Technical Bulletin

Model(s)	Year	Eng. Code	Trans. Code	VIN Range From	VIN Range To
(A5) Jetta, Eos, GTI, Passat, Passat Wagon	2006-2008	2.0L (BPY)	All	All	All

20 08 05 Jul. 21, 2008 2017718

EVAP Purge Valve -N80-, Replacement

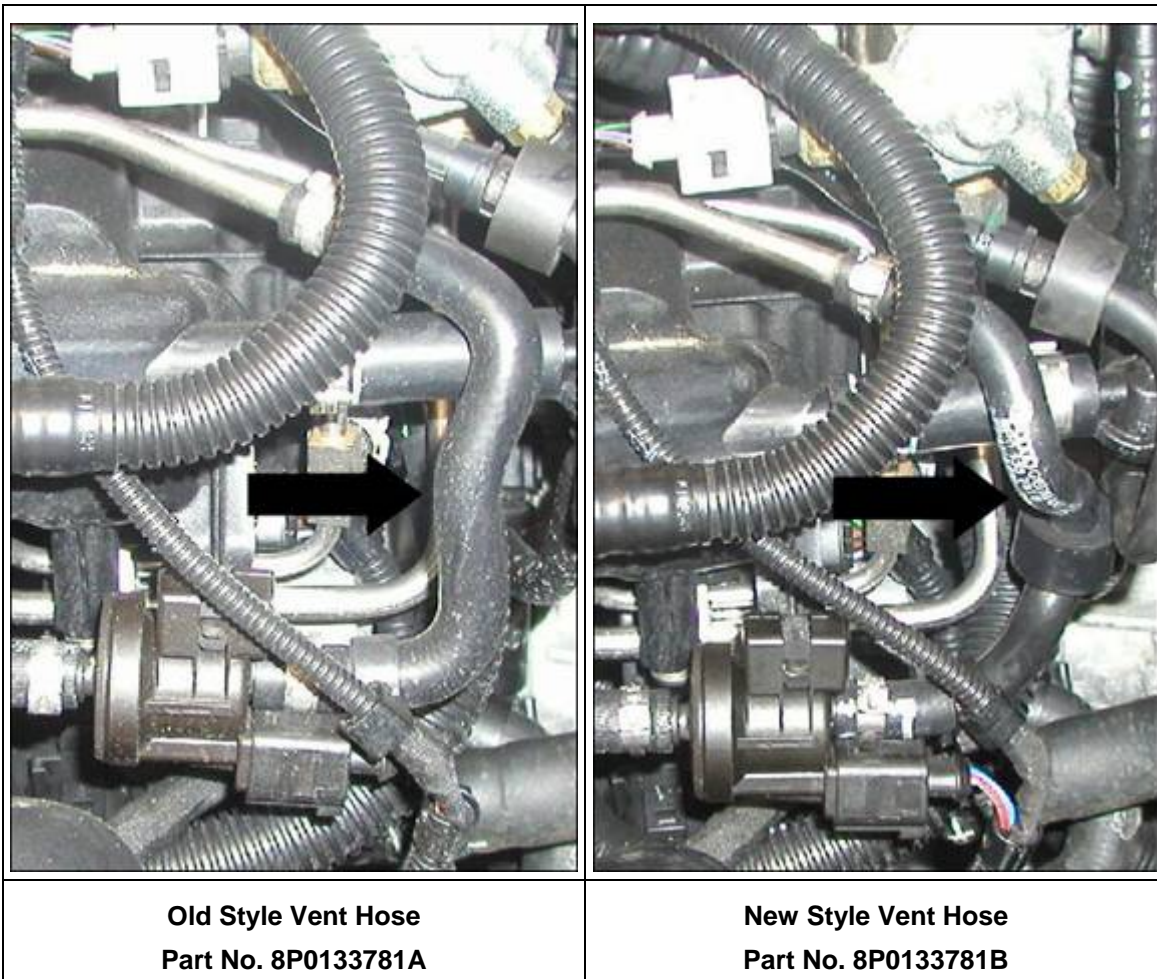
New design vent hose Part No. 8P0133781B for EVAP purge valve -N80- to improve EVAP system performance.

Vent hose Part No. 8P0133781B is clearly marked to ensure correct installation.

Slide hose onto pipe and valve, at a minimal, up to painted white line on hose before clamping.

Ensure new vent hose is not bent, twisted or chaffing other components.

Whenever diagnosis leads to EVAP purge valve -N80- replacement, inspect and ensure installation of new, -N80- valve vent hose Part No. 8P0133781B.

Secure new valve vent hose with spring clamps Part No. N10199201.
